**RIMROCK RANCH
SPECIFIC PLAN AND FINAL EIR**

State Clearinghouse # 98092066

November 2000

II. COMMENT LETTERS & RESPONSES TO COMMENTS

**GROUNDWATER ELEVATION
 CONTOUR MAP**

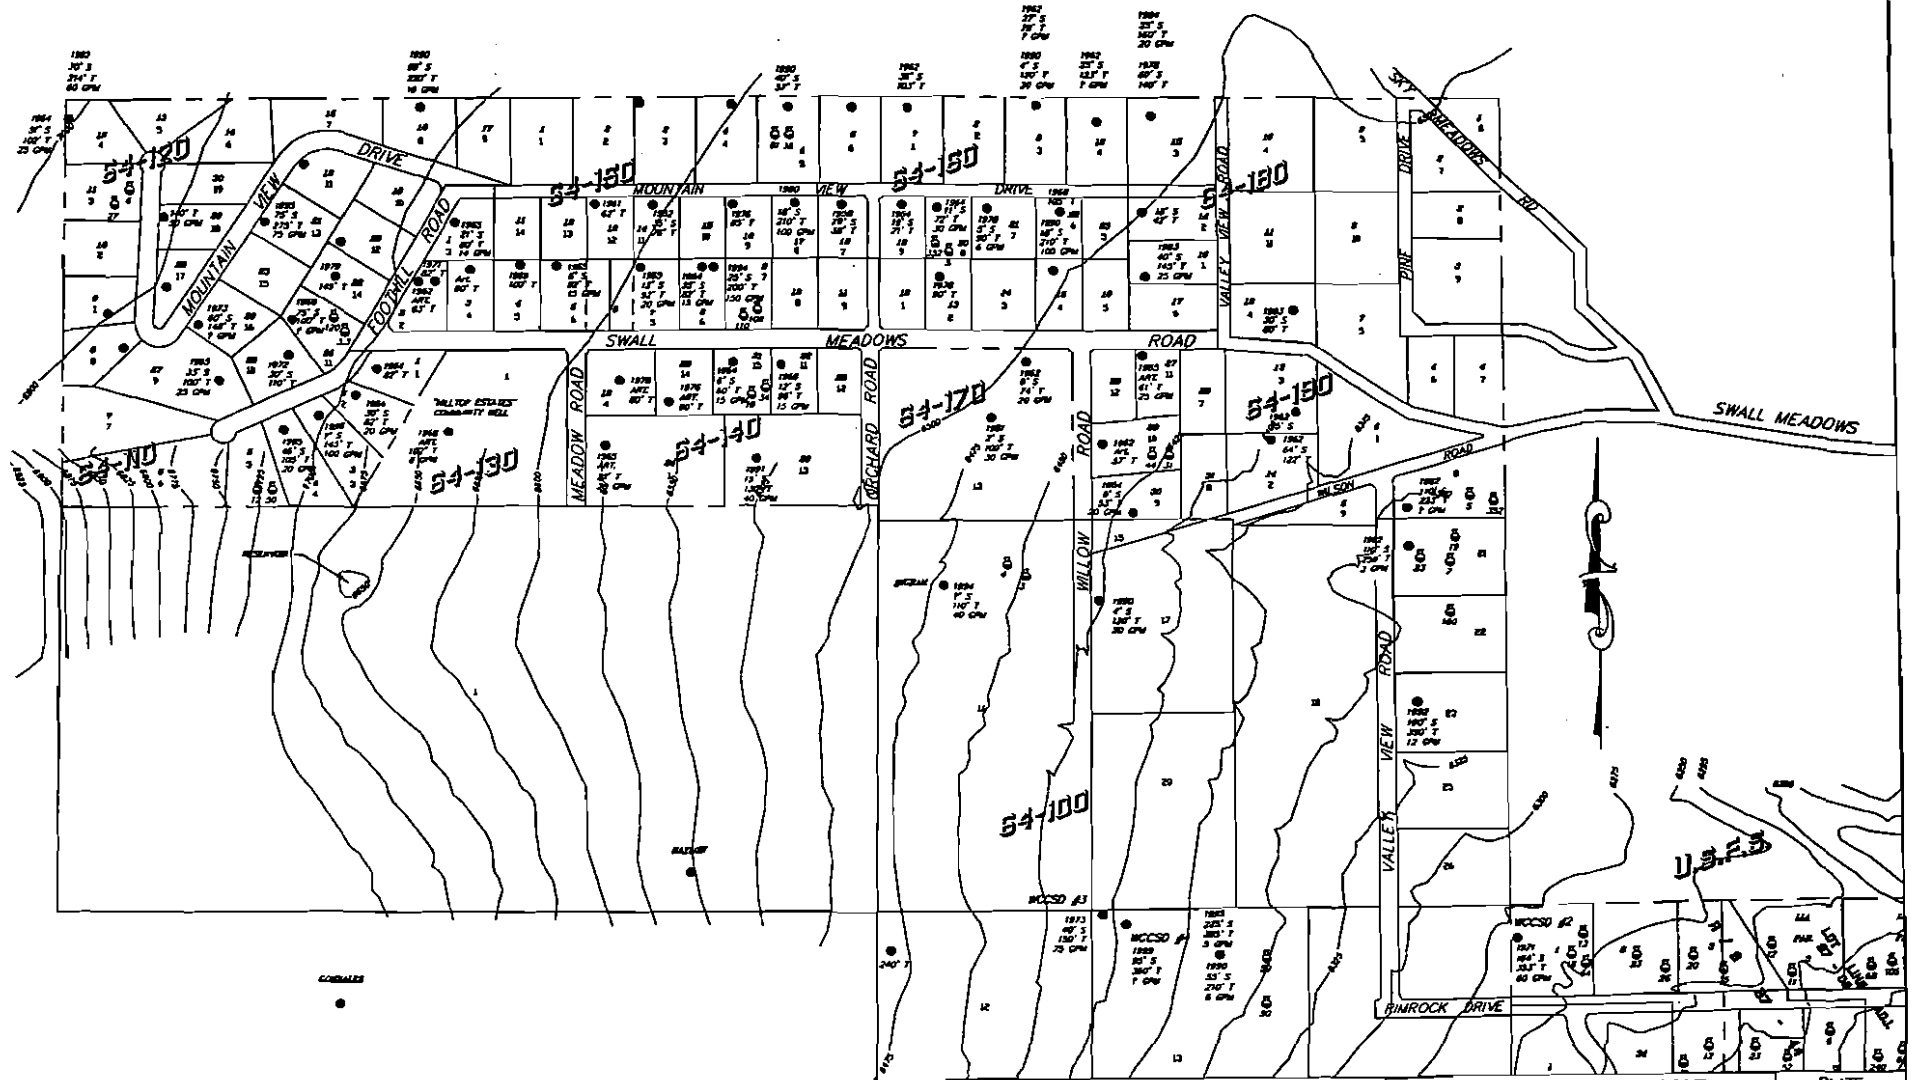
The depths to water were measured in twelve water supply wells by Kleinfelder using a calibrated electronic tape on November 9, 10 & 17, 2000. Depth to water, measuring point elevation and water elevation in these wells are summarized in Table 3. The only other water level data available to Kleinfelder as of this report were from drillers logs at time of well construction and data collected from the WCCSD Well 4 aquifer performance test conducted in 1999. Using the data presented in Table 3 we prepared Plates 7 through 10 that show the assessed depth to groundwater and the hydraulic gradient, respectively.

**ASSESSOR PARCEL MAP,
 SWALL MEADOWS SUBDIVISION**
 RIMROCK RANCH WATER RESOURCES
 ASSESSMENT
 MONO COUNTY PLANNING DEPARTMENT,
 CALIFORNIA

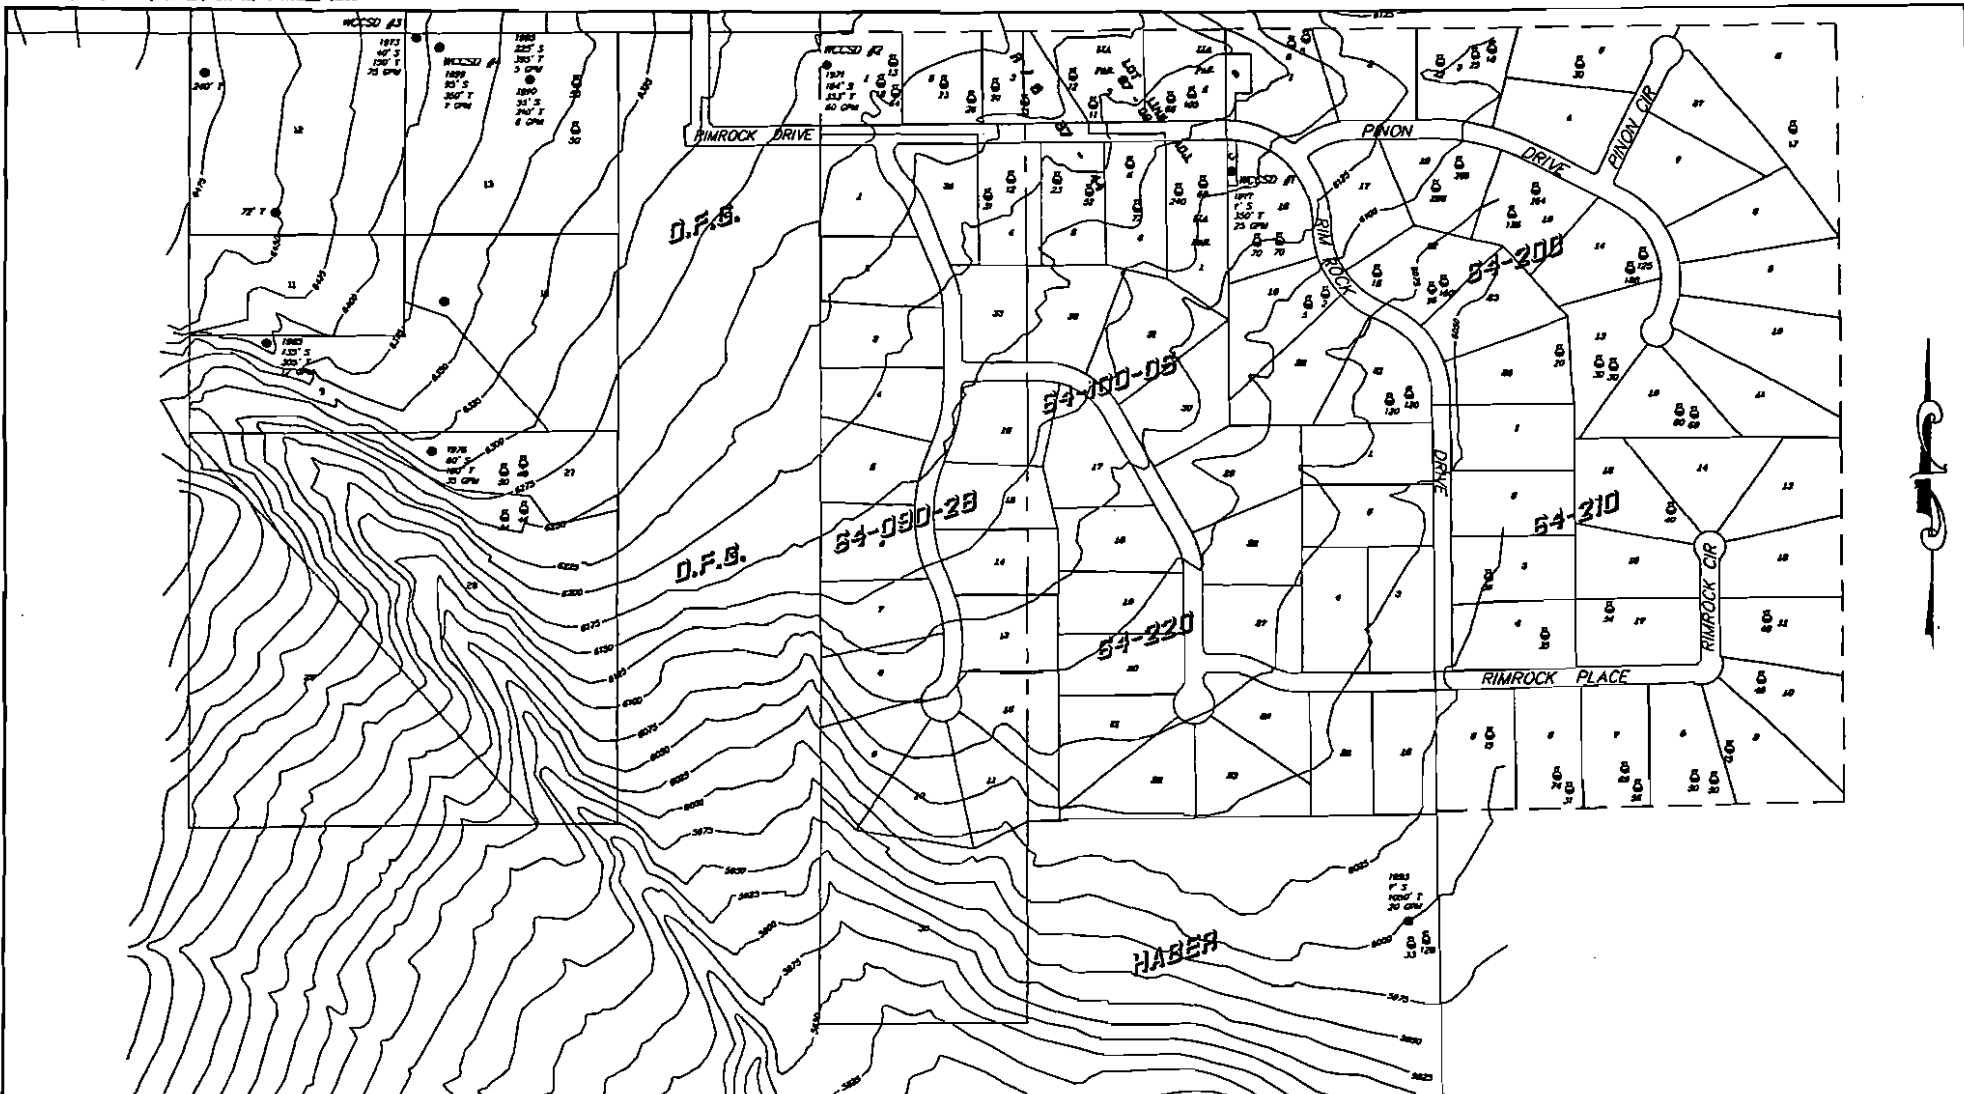
WCCSD well #4 is located as shown on Plate 7. An understanding of the hydrogeology and hydraulics of this well is important since it the proposed source for the planned development. The well was constructed to a reported depth of 387 feet. Rock (possibly tuff based on drillers log) was encountered at a depth of approximately 155-165 feet. The well is screened from 78 to 378 feet below land surface. On December 31, 1998 the depth to water in the well was assessed at 97 feet. During our site visit of November 17, 2000 the depth to water was measured at 112.1 feet. Based on a air lift test, the well was rated to produce 50 gallons per minute.
